**Service information SI\_2016\_100\_0180\_Intuition**

<b>System type:</b> Intuition 4C	<b>Serial numbers:</b> n.a	<b>Date issued:</b> 2017-04-07
<b>ServiceInfo number:</b> SI_2017_101_0180_Intuition	<b>Issued by:</b> Jonas Petersson	<b>Approved by:</b> Mikael Högberg
<b>Time for action:</b> WHEN CONVENIENT	<b>Report back to Arcoma:</b> N.a	<b>Ref nr: (ÄBO, Complaint)</b> N.a
<b>Subject:</b> <b>Anti-scatter grid position</b>

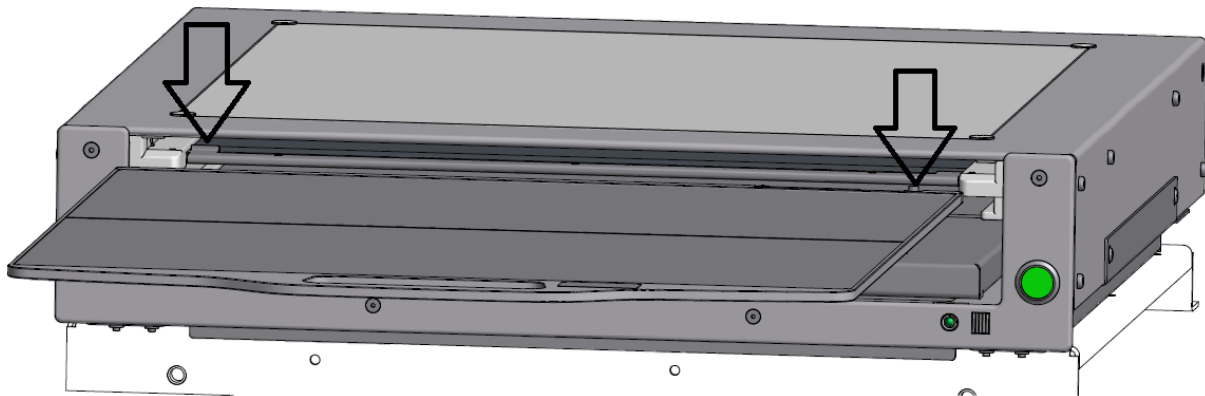
Arcoma received complaints related to the fact that anti scatter grids can be inserted the wrong way in some models of detector holders for both table and wall stands.

Inserting the grid incorrectly may affect image quality and cause additional x-ray exposures to patients.

A mechanical device preventing incorrect insertion will be implemented in production for the assembly of Intuition system s/n 2036. See image below.

A field upgrade kit will be available from Arcoma AB. Please identify the quantity of kits needed by your organization and order them FOC from [service@arcoma.se](mailto:service@arcoma.se)  
All systems of the specific configuration mentioned above must be upgraded on the next scheduled service intervention.

- Install the upgrade kit and replace page(s) in the User manual in accordance to the supplied instruction.
- Sign and return the confirmation form to Arcoma AB as soon as the required action has been performed.
